# **Safety Evaluation Report**

related to the construction of the  
Clinch River Breeder Reactor Plant

Docket No. 50-537

**U.S. Nuclear Regulatory  
Commission**

Figure A 5.1 Chronology of CDA release model applicants' base case

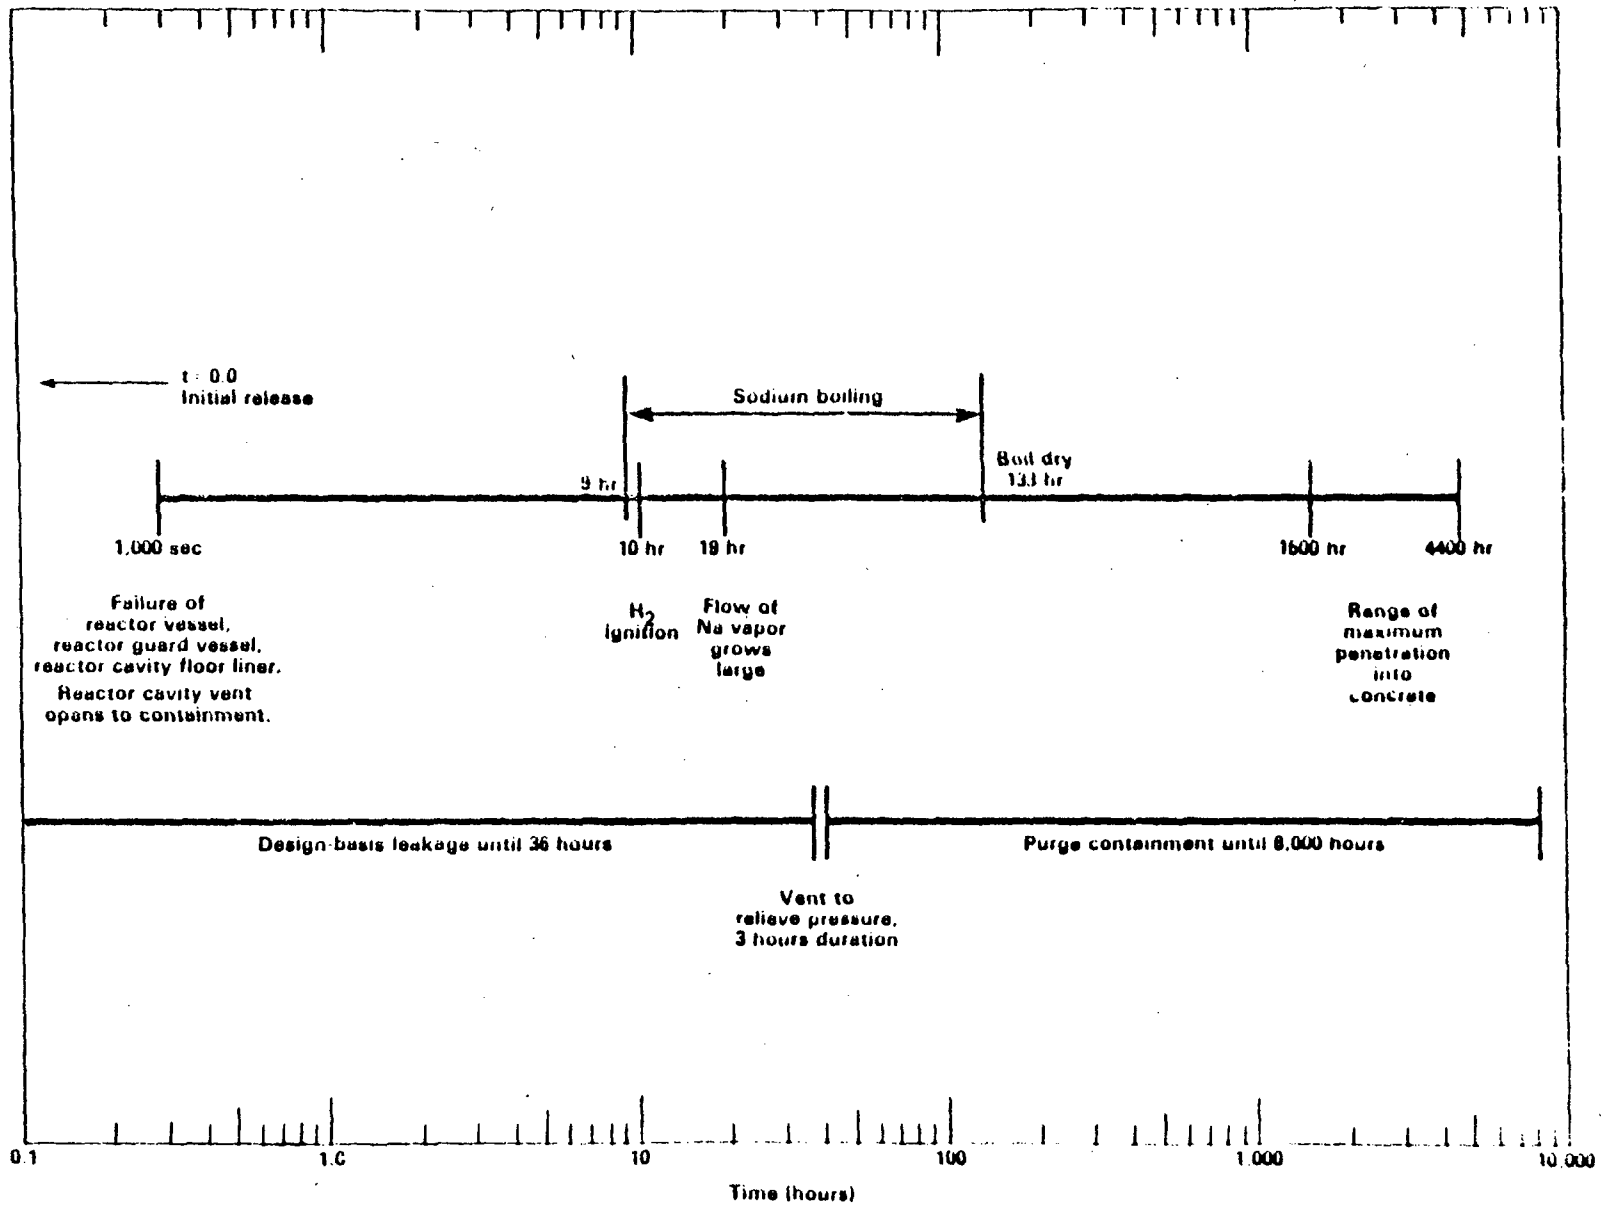
Whether specific radionuclides are released to the environment depends on the mode of their release to the containment atmosphere, on the conditions of the containment atmosphere, and on the containment system mode of operation during the period the radionuclides are in the containment atmosphere available for release. Figure A.5-1 shows the relative timing of these conditions for the core disruptive accident which the applicants have designated their base case in CRBRP-3 (Reference 1). The approximate timing for the staff's realistic upper bound case would have hydrogen ignition at about eight hours, venting at about 22 hours and boil-dry at some time greater than 70 hours.

Table A.5-3 presents the applicants' calculated results, comparing the Margin Assessment Case to their base case; the applicants' base case assumes one-half inch per hour for 4 hours. The Table shows that the containment conditions do not differ greatly from the applicants' base case. The applicants assert feasible modifications can increase the design margins so that the plant design will accommodate the Margin Assessment Case. Table A.5-4 presents calculated radiological consequences of these two cases. The staff's evaluation of these results and those for intermediate reaction rates and venting times is that these results are reasonable and that the radiological consequences are relatively insensitive to venting initiation times between 10 and 36 hours.
